737

Service Bulletin

Number: 737-27-1282
Original Issue: March 15, 2007
Revision 2: September 04, 2015
ATA System: 2721

SUBJECT: FLIGHT CONTROLS - Rudder and Rudder Trim Control System - Wire Bundle W443
and Left Forward Rudder Quadrant Clearance Inspection

**FIGURE 1: WIRE BUNDLE W443 INSPECTION FOR DAMAGE
(SHEET 1 OF 2)**

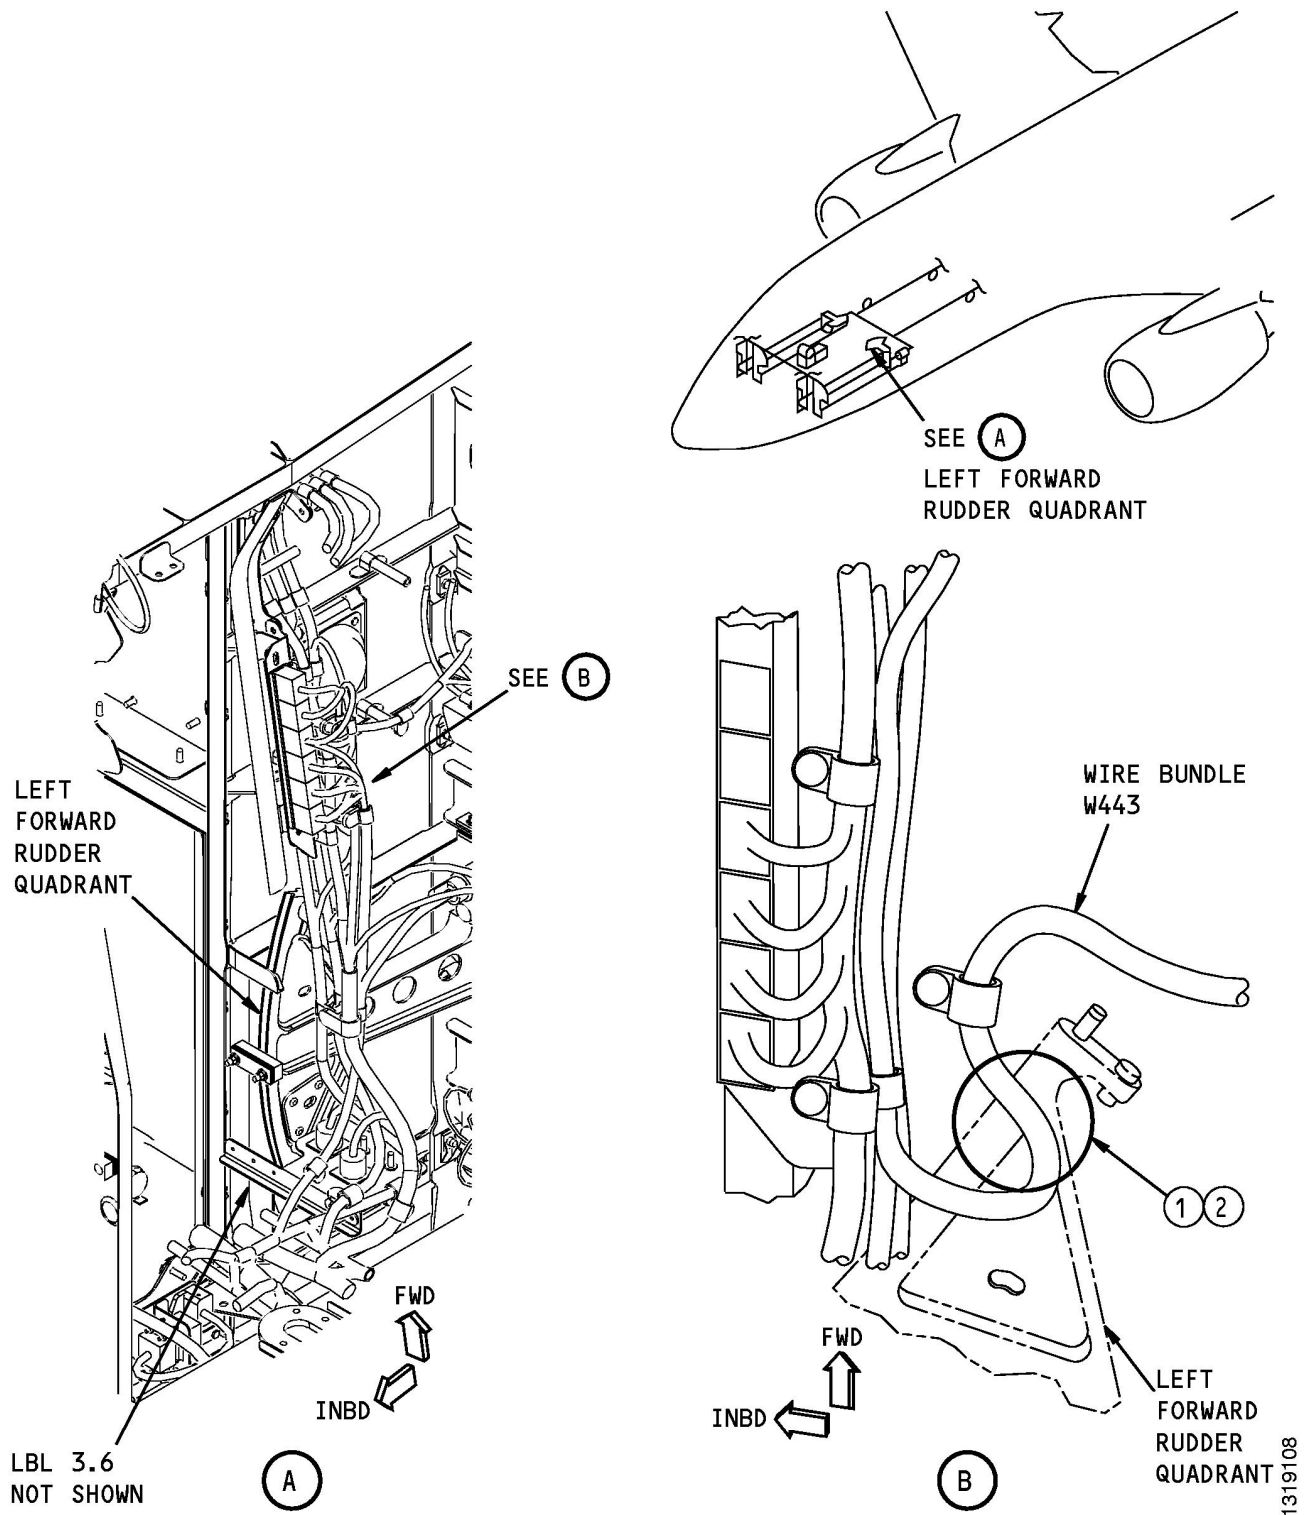
5. Part 1: Wire Bundle W443 Inspection for damage.
 - a. Push and hold the pilot's right rudder pedal fully to the travel stops.
 - b. Do a detailed inspection of the wire bundle W443 for damage and measure for a minimum clearance of 0.5 inch in accordance with FIGURE 1.

- (1) If the wire bundle is not damaged and a minimum 0.5 inch clearance exists between the forward rudder quadrant, then put the airplane back to a serviceable condition.

- (2) If the wire bundle is not damaged and a 0.5 inch clearance does not exist between the forward rudder quadrant, then do Part 2: Wire Bundle W443 Clearance Adjustment.

- (3) If the wire bundle is damaged then repair in accordance with Part 3: Wire Bundle W443 Repair and Clearance Adjustment.
 - c. Slowly release the pilot's right rudder pedal fully.

STEP	TASK	NAME	IDENTIFICATION	QTY	MORE DATA
1	Inspect	Wire Bundle	W443	-	do a detailed inspection for damage to the wire bundle protection sleeve, and/or damage to the wire jacket or insulation. (a)
2	Measure	Wire Bundle Clearance	W443	-	for a minimum clearance of 0.5 inch from left forward rudder quadrant full travel motion.
(a) Refer to SWPM 20-10-13 and SWPM 20-10-06, as accepted procedures.

**FIGURE 2: WIRE BUNDLE W443 CLEARANCE ADJUSTMENT
(SHEET 1 OF 2)**

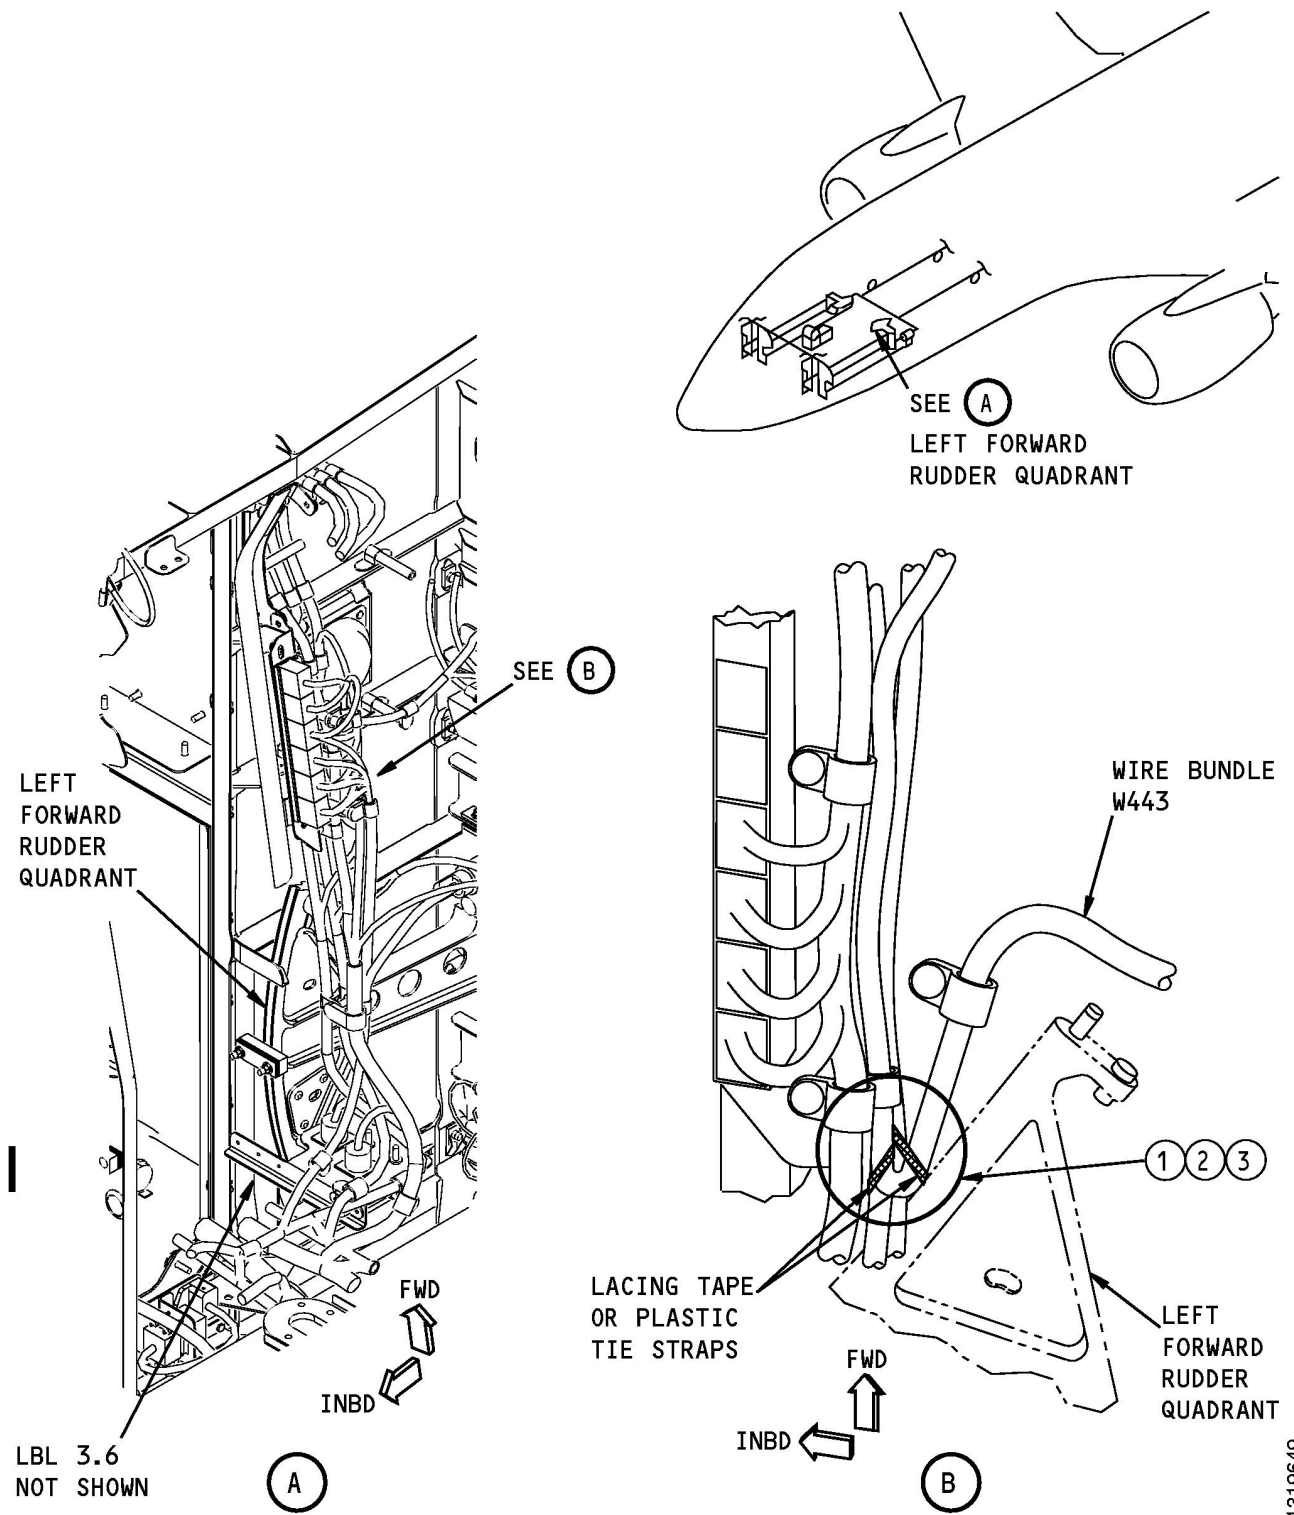
6. Part 2: Wire Bundle W443 Clearance Adjustment.
 - a. Adjust the wire bundle clearance in accordance with FIGURE 2.
 - b. Push and hold the pilot's right rudder pedal fully to the travel stops. Make sure there is a minimum clearance of 0.5 inch in accordance with FIGURE 2.

STEP	TASK	NAME	IDENTIFICATION	QTY	MORE DATA
1	Adjust	Wire Bundle	W443	-	route as straight as possible. Refer to SWPM 20-10-11 and SWPM 20-10-12, as accepted procedures. (a) (b) (c) (d)
2	Route / Attach	Wire Bundle	W443	-	to the adjacent wire bundles, as necessary. Refer to SWPM 20-10-11 and SWPM 20-10-19, as accepted procedures. (b) (c) (d)
3	Measure	Wire Bundle Clearance	W443	-	for a minimum clearance of 0.5 inch from left forward rudder quadrant full travel motion.
(a)	Minimize bend radius.				
(b)	Adjust wire bundle to make sure that contact is not made with any part that moves.				
(c)	Adjust wire bundle to increase the minimum clearance to 0.5 inch.				
(d)	Cut and install lacing tape (part number BMS 13-54 Type III) or install plastic tie straps (part number BACS38K9), as an approved alternative, to hold wire bundle in position.
